# Work Order ID 56550

Item Name: Lug Upgrade Kit, 206 A/B Float Step

# DART SERVICE INSTRUCTION

TO AMEND INSTALLATION INSTRUCTIONS IIN-D206-628 REV. F

FIGURE 1  
D206-628-013 (SHOWN) / -014 (OPPOSITE)  
206 A/B FLOAT STEP INSTALLATION

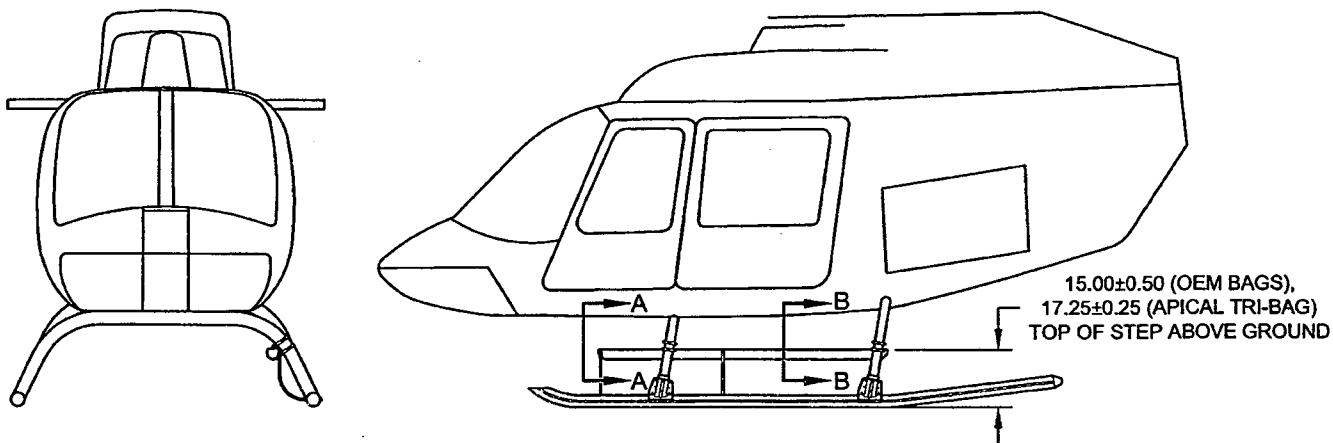
THE DSI-9500-011 LUG UPGRADE KIT IS AVAILABLE TO UPDATE EXISTING D206-628-013/-014 STEPS TO CHANGE 006. THE UPGRADE KIT INCLUDES ADDITIONAL LUGS FOR STEPS INSTALLED WITH APICAL TRI-BAG FLOATS (AT 17.25" HEIGHT). EXISTING D206-628-013/-014 STEPS INSTALLED WITH OEM FLOATS (AT 15.00" HEIGHT) DO NOT REQUIRE THE KIT. THE UPGRADE KIT SHOULD BE INSTALLED PER THIS SERVICE INSTRUCTION AND IIN-D206-628 REV. F.

CONTRARY TO INSTALLATION INSTRUCTIONS IIN-D206-628, FOR COMPATIBILITY WITH APICAL TRI-BAG FLOATS, THE D206-628-013/-014 STEP INSTALLATIONS SHOULD BE INSTALLED AT A HEIGHT OF 17.25" PER FIGURE 1 OF THIS SERVICE INSTRUCTION.

SECTION A-A  
FWD CROSSTUBE CLAMPING DETAIL

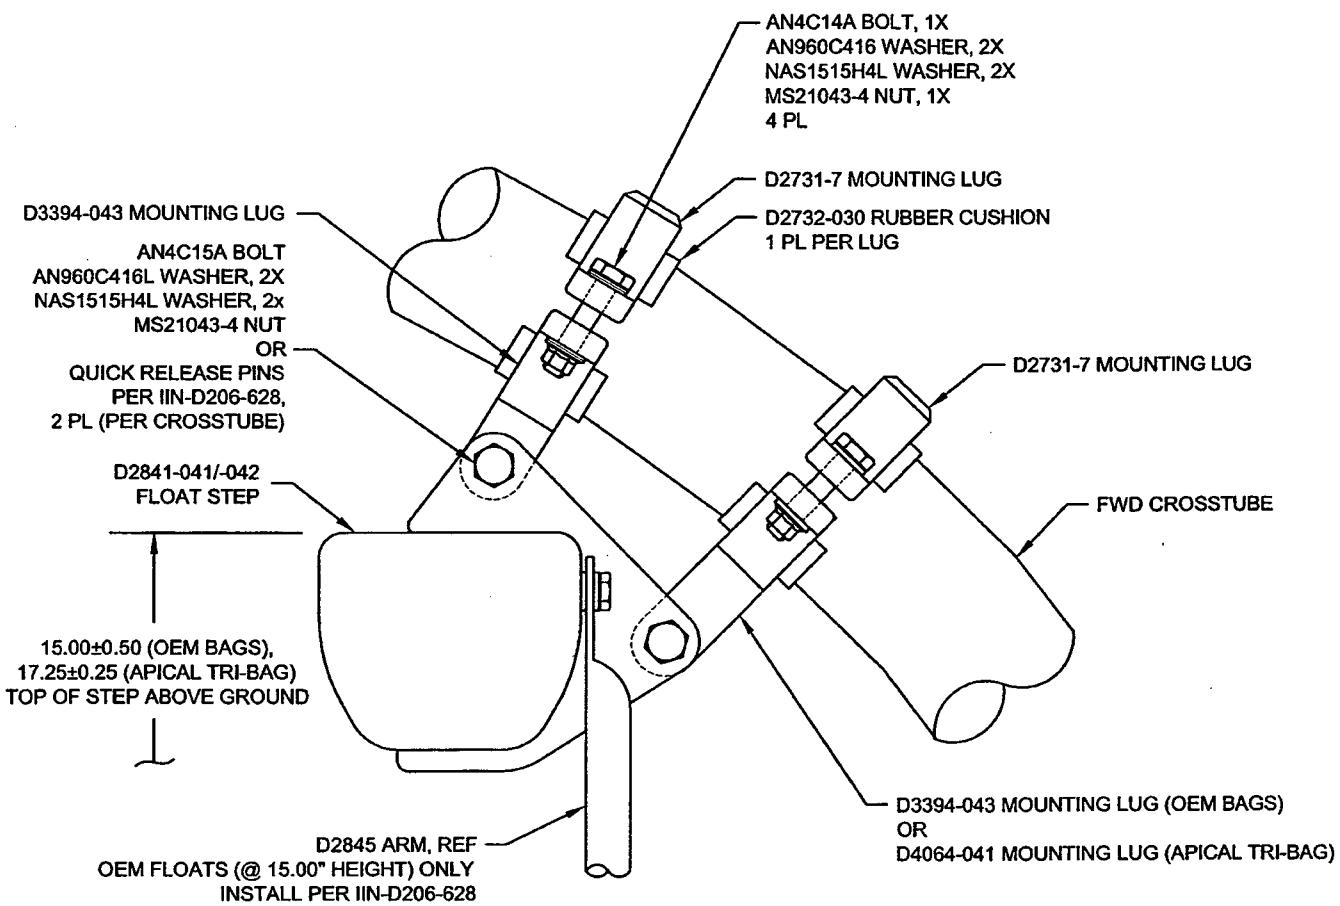
WHEN INSTALLING THE MOUNTING LUGS, IT IS ACCEPTABLE TO USE LONGER/SHORTER AN4C BOLTS AS REQUIRED AND/OR INSTALL EXTRA AN960C416/416L WASHERS UNDER THE BOLT HEADS TO ENSURE 1.5 TO 4 THREADS IN SAFETY.
